ADDENDUM
NO. 2

April 20, 2021

HANOVER CENTRAL HIGH SCHOOL ADDITIONS AND RENOVATIONS
Cedar Lake, IN 46303

Addendum Two (AD.02) to the drawings and specifications prepared by Gibraltar Design and The Skillman Corporation for **Hanover High School Addition and Renovations** for Hanover Community School Corporation, Cedar Lake, Indiana.

SHEET MV104

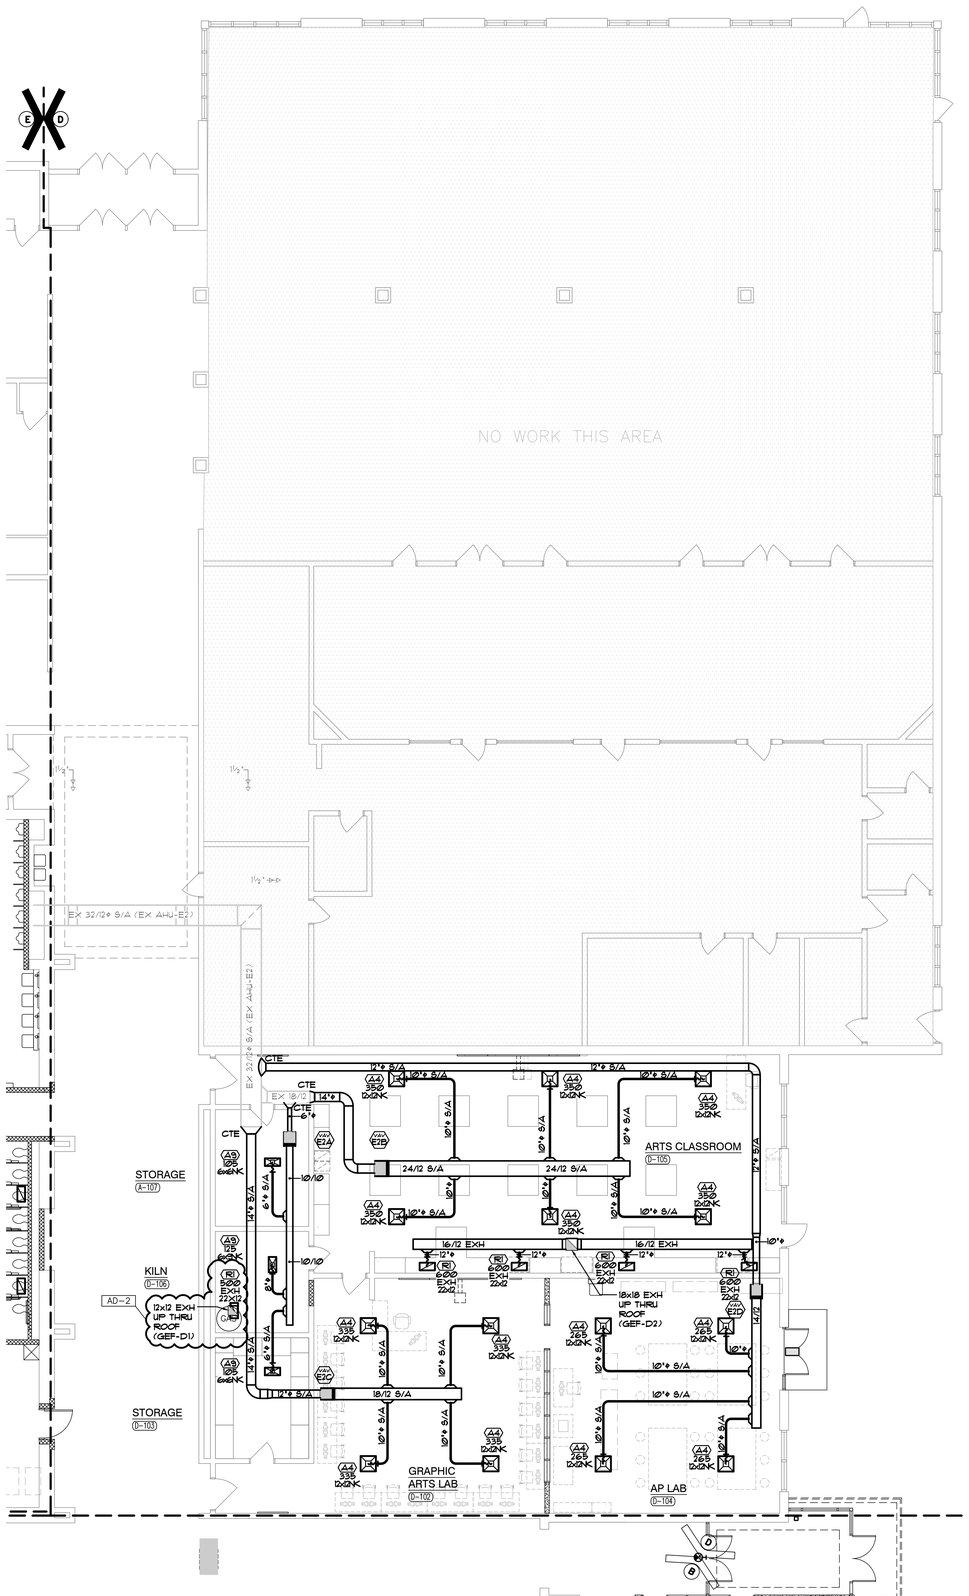
37. Sheet MV104

A. Refer to revised full-size drawing, included in this Addendum, for the following revisions:

1. Added tags for GEF-D1 ductwork

SHEET MV106

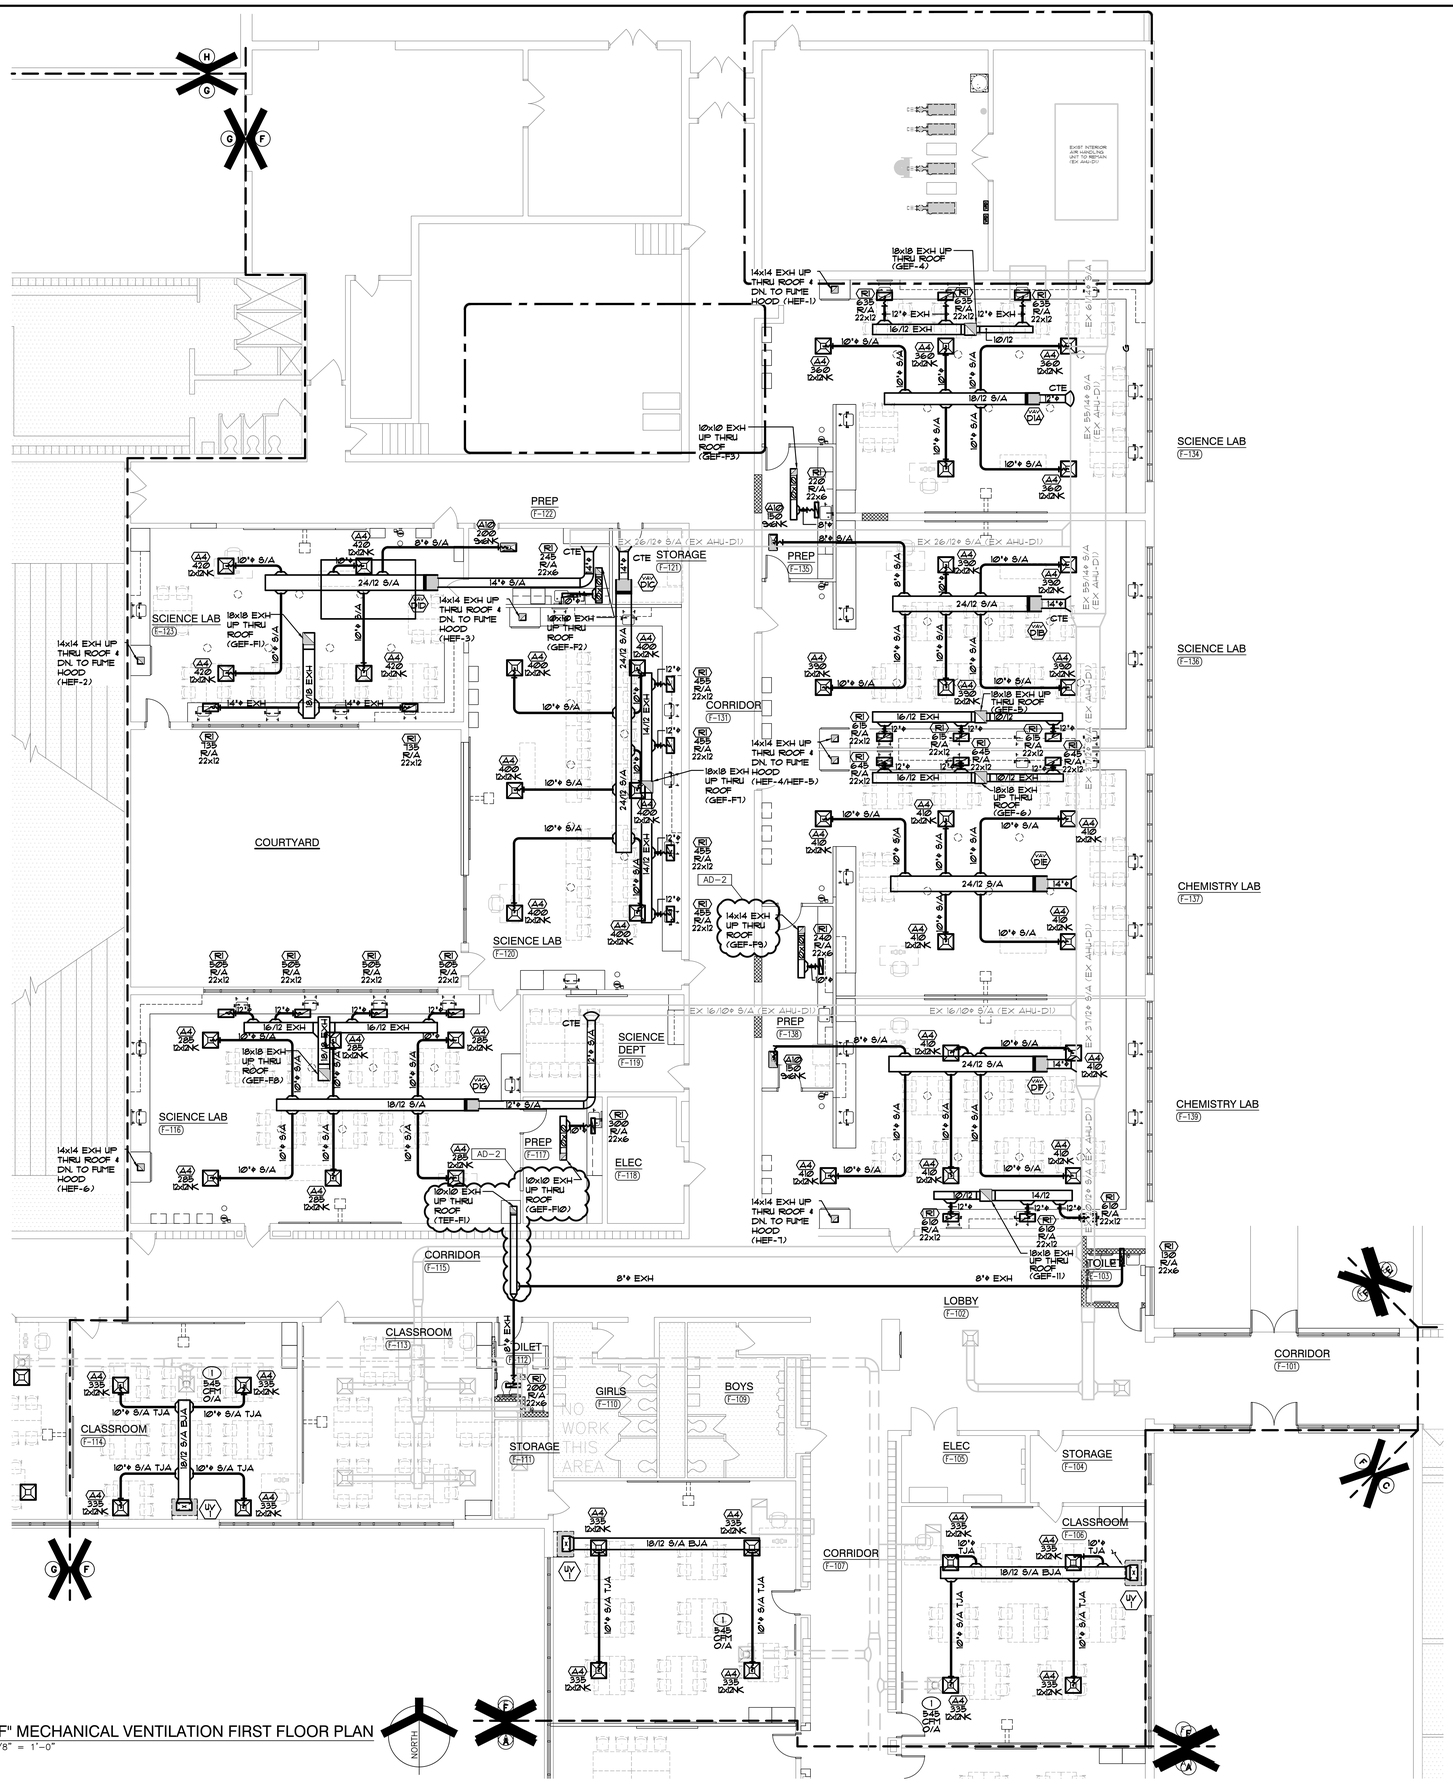
38. Sheet MV106

A. Refer to revised full-size drawing, included in this Addendum, for the following revisions:

1. Relocated TEF-F1
2. Added proper tags to duct rises to GEF-F10 and GEF-F9

SHEET MP101A

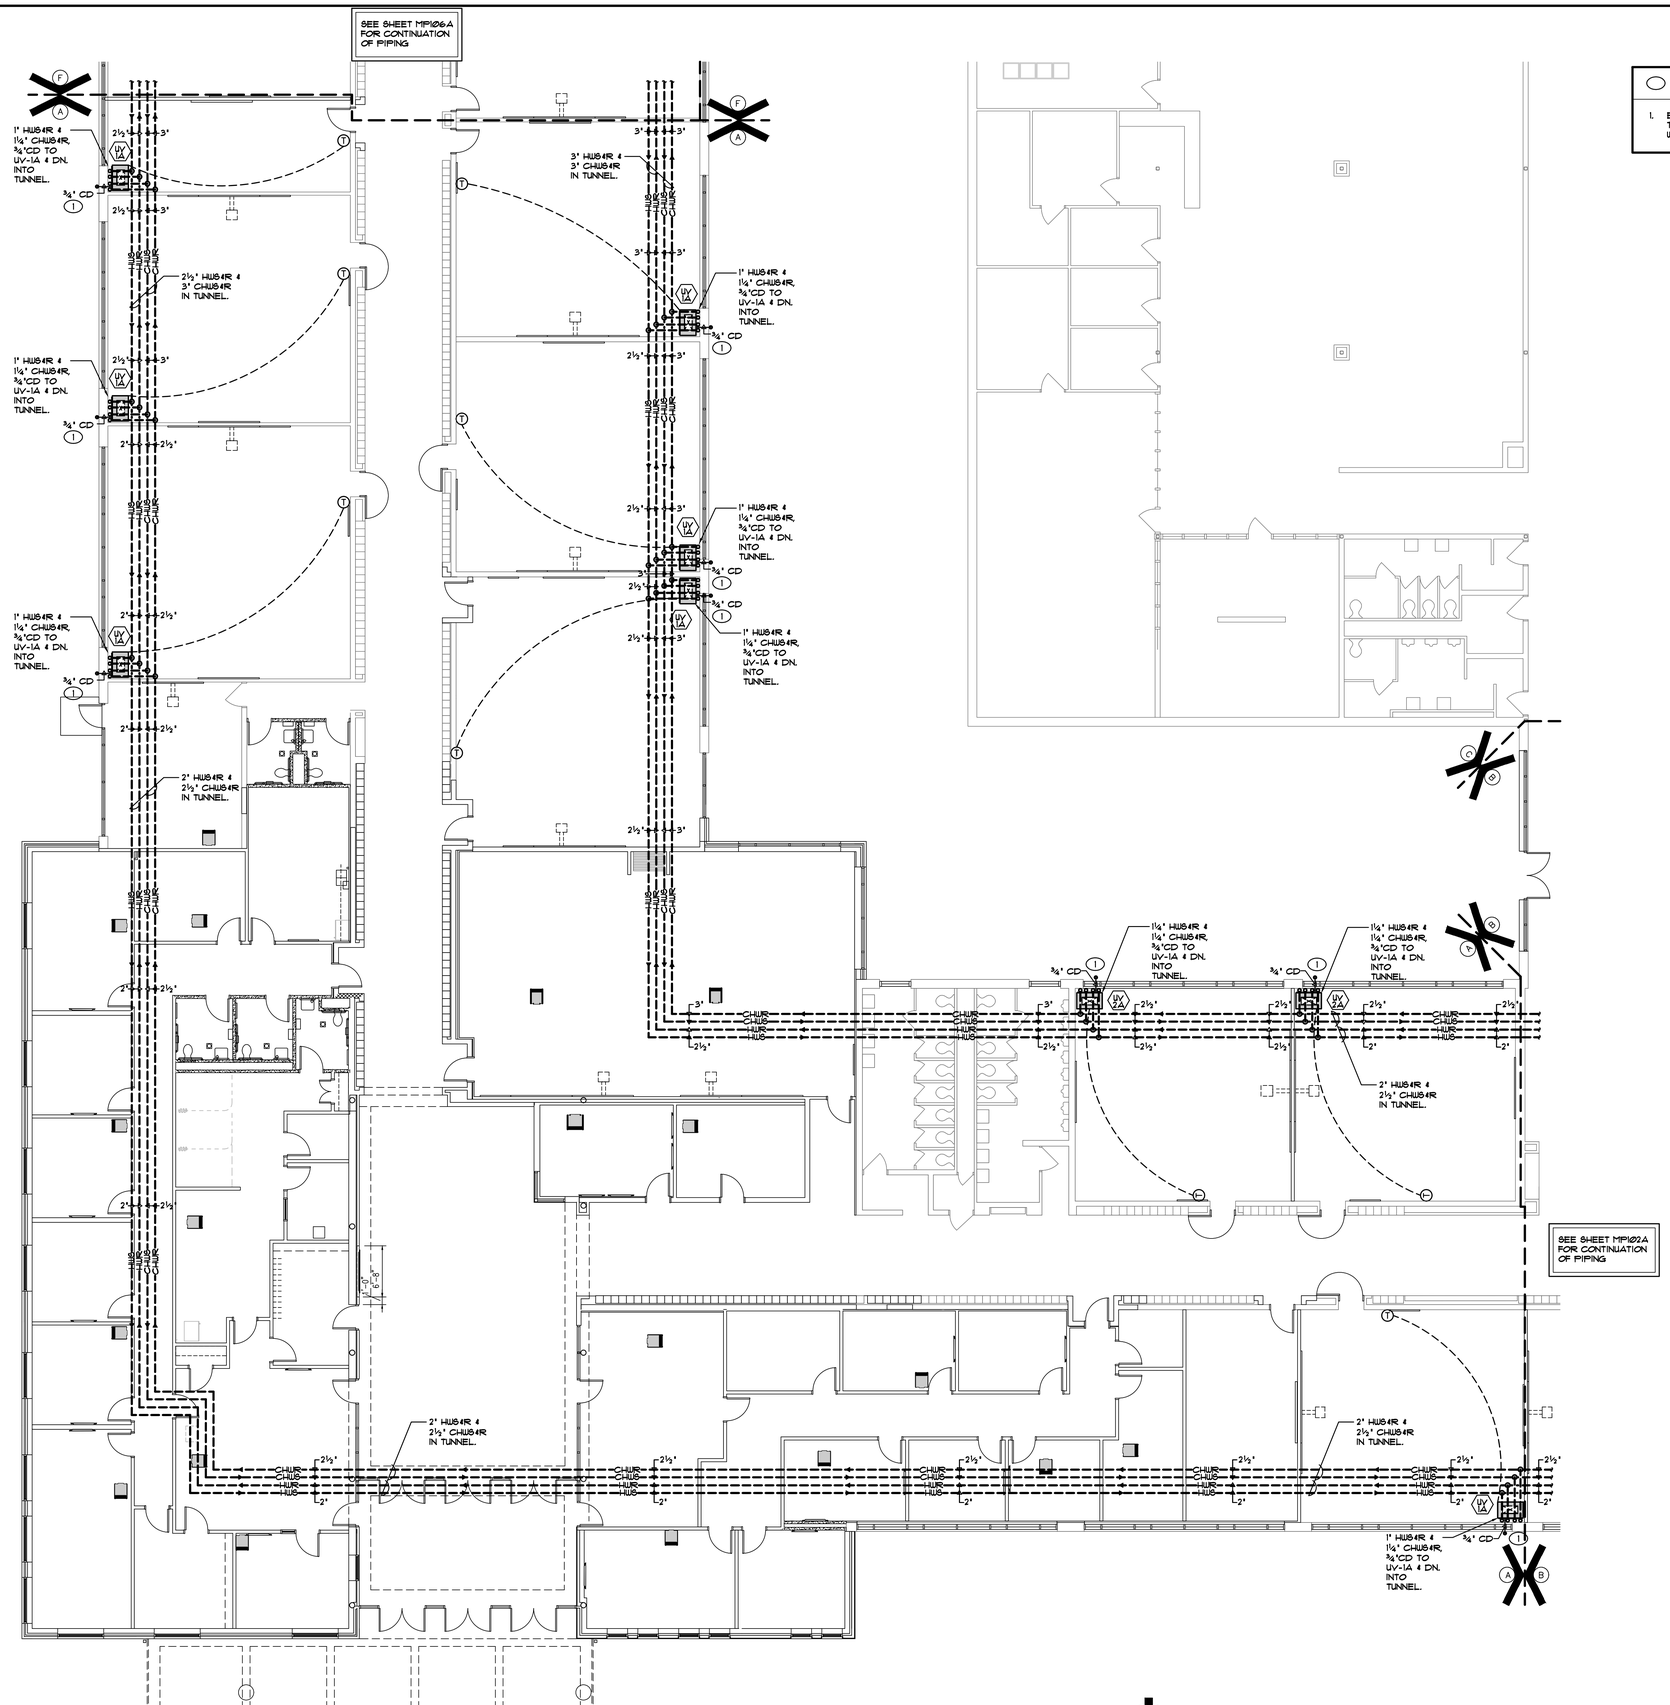
41. Sheet MP101A

A. Add new full-size drawing, included in this Addendum, for the following:

UNIT "F" MECHANICAL PIPING FIRST FLOOR PLAN - ALTERNATE

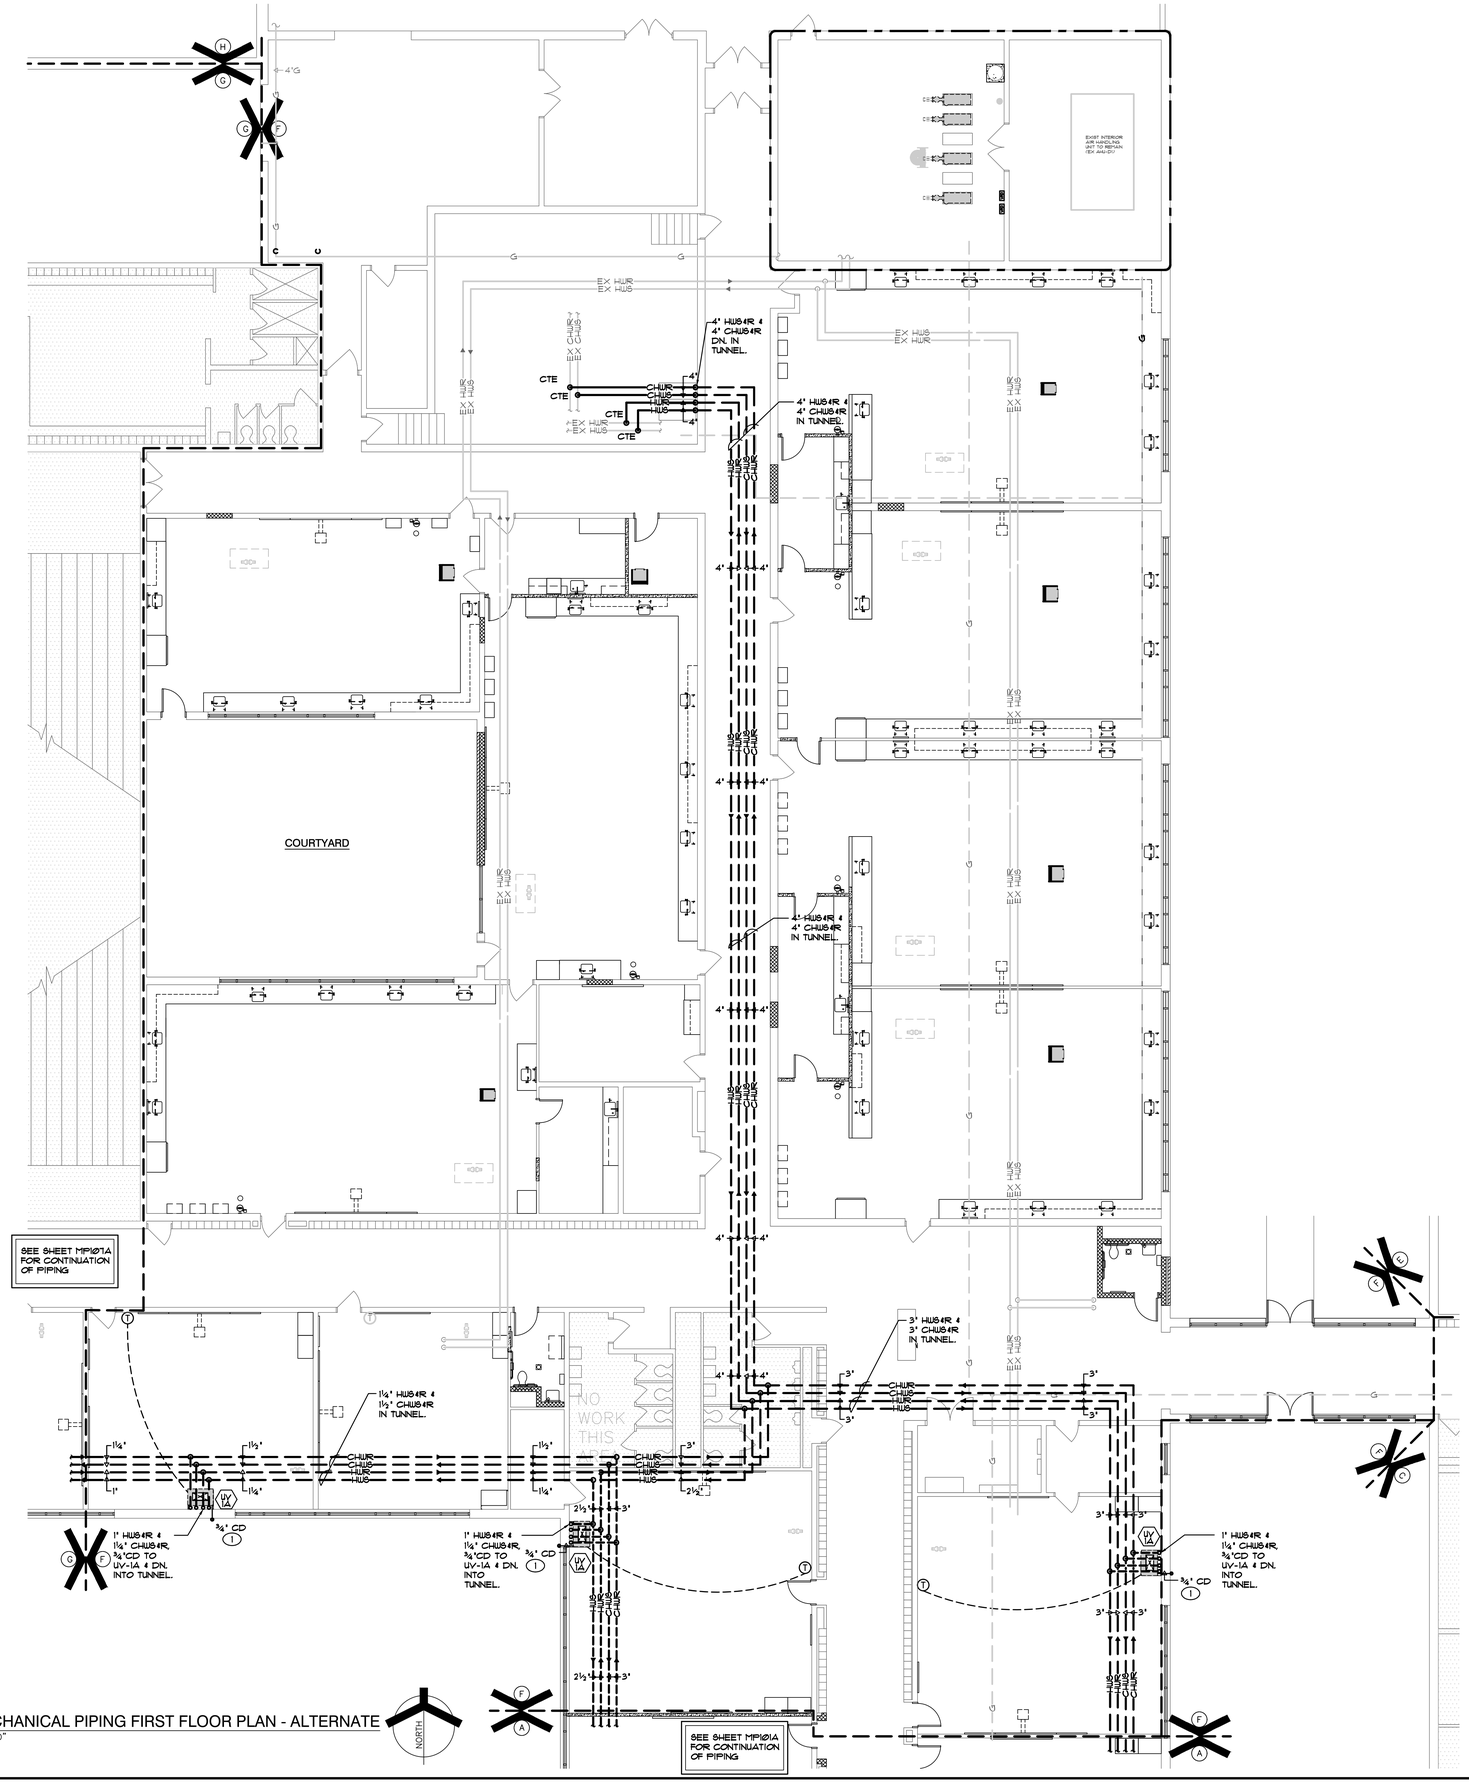
43. Sheet MP106A

A. Add new full-size drawing, included in this Addendum, for the following:

1. Added new sheet for alternate underfloor piping and rerouted and resized hot and chilled water supply and return.
